**MEMORANDUM**

Date: March 30, 2011

File: **P080006/S002**
Attain Ability Plus Model 4296 Lead

Sponsor: Medtronic, Inc.

Figure 1. Comparison of Model 4196 and Model 4296 Leads

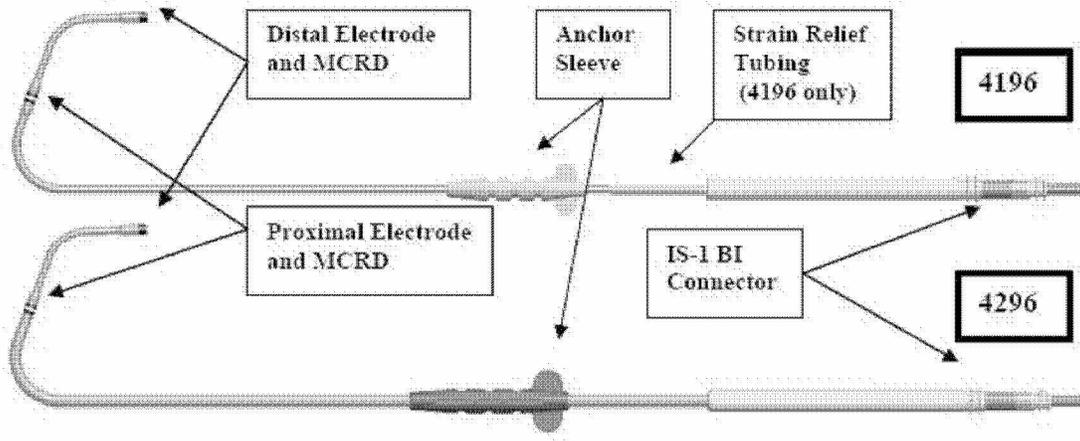
The primary differences between the Model 4196 and Model 4296 leads are (1) the lead body dimension, (2) the absence of strain relief tubing at the distal tubing of the connector sleeve in the Model 4296 lead and (3) a different anchor sleeve used for the thicker lead. These changes were made to improve the handling characteristics of the lead to be similar to the Attain Over-the-Wire Lead Model 4194 lead (P010015/S012), a thicker lead. The differences are highlighted in Figure below.

The lead body tubing that spans the 4196 lead from the proximal end of the proximal electrode will be replaced by a lead body tubing of the same 55D polyurethane material with the same inner diameter of 0.034" but with a larger outer diameter of 0.069" (~5.3 Fr). The distal end of the lead body tubing is shaped to transition to the same diameter as the Model 4196 over the most distal 0.160" of the tubing (3.4 Fr).

The silicone strain relief tubing in the connector sleeve area of the 4196 lead design is no longer needed and has been removed for the 4296 lead. The new lead body tubing takes the place of this tubing under the connector sleeve and provides a stiffer lead body in this area.

The anchor sleeve for the Model 4296 lead has larger dimensions than the anchoring sleeve for the Model 4196 lead due to the larger diameter of the lead body tubing. This is the same anchoring sleeve currently used on the Model 4074 lead body (P830061/S034, approved July 23, 2002).
